Danescourt Community Association

**Planning Application 20/00187/MJR
Residential Development for 45 Dwellings - Land at De Braose Close,
Danescourt, Cardiff**

OBJECTION

Fig.1 The woodland in Summer. Note the absence of littering & ground disturbance

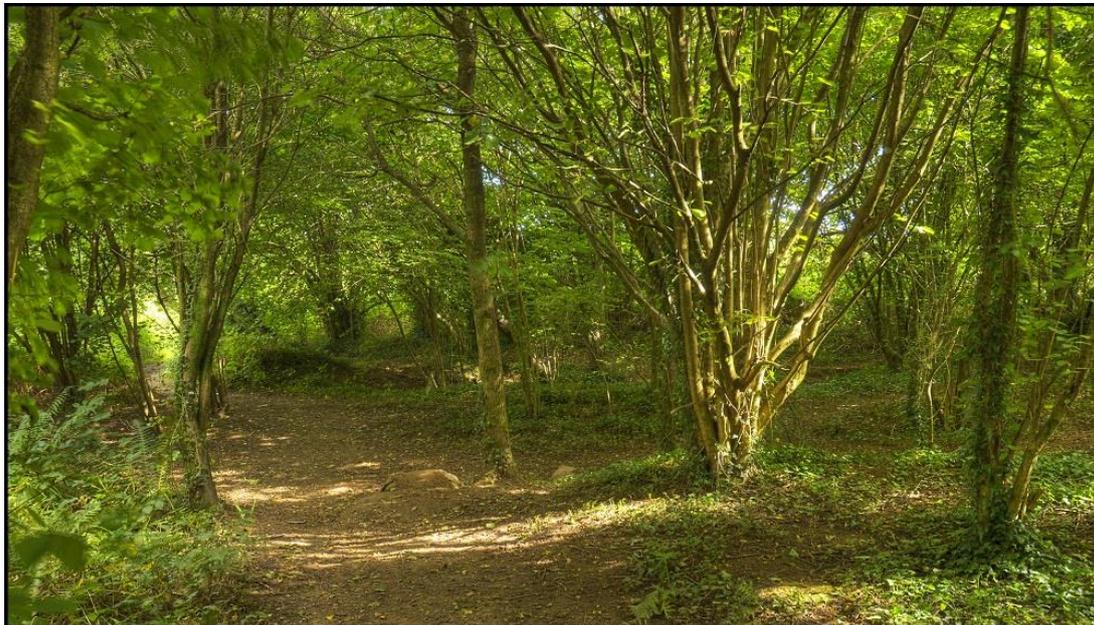
5. The woodland is described as having little ecological value within the Green Infrastructure Statement and several illustrations included within the Applicant's submitted documents display it as being not particularly attractive. The submitted photographs have all been taken during the autumn or perhaps winter however when the deciduous woodland has abandoned all its greenery and hardly looks at its best. A photograph taken in summer which is attached hereto shows how really attractive this woodland actually is. (Fig.1)

7. The Design and Access Statement states the site is *"subject to regular public use, with littering and ground disturbance widespread."* Reference to Fig.1 also shows this description to be wrong.

Fig.3 Natural Resources Wales Flood Risk Map

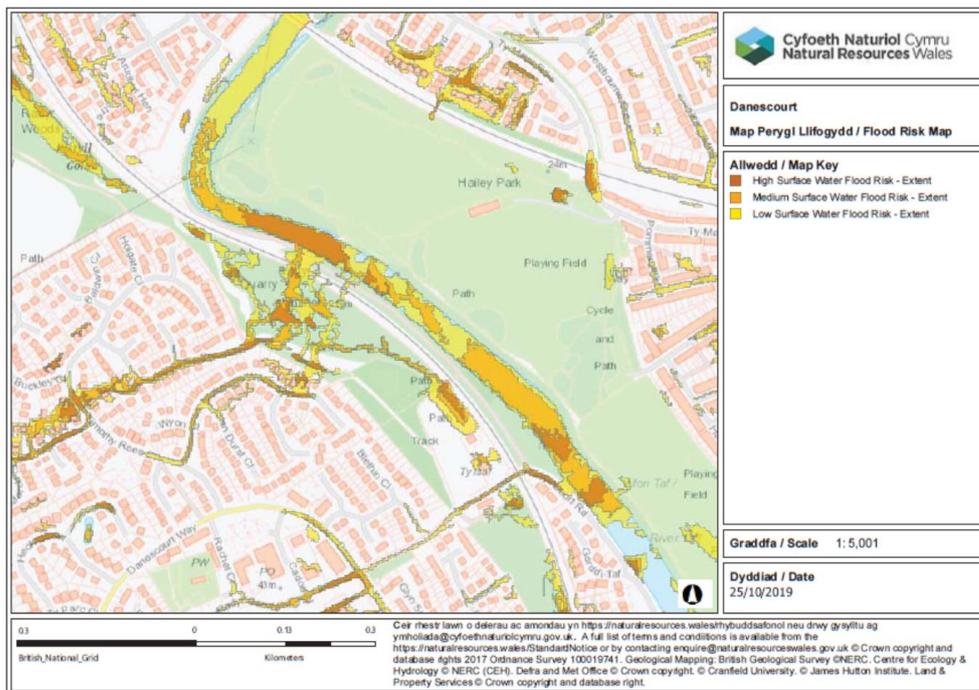
26. The NRW Development plan shows the flood risk areas with the site to be at the end of a surface water flow path corridor (Fig.3). Development of the site will alter the route of this flow path corridor and could lead to additional flooding, either within the site or in areas adjacent to it. This situation has not been considered within the submitted drainage design.
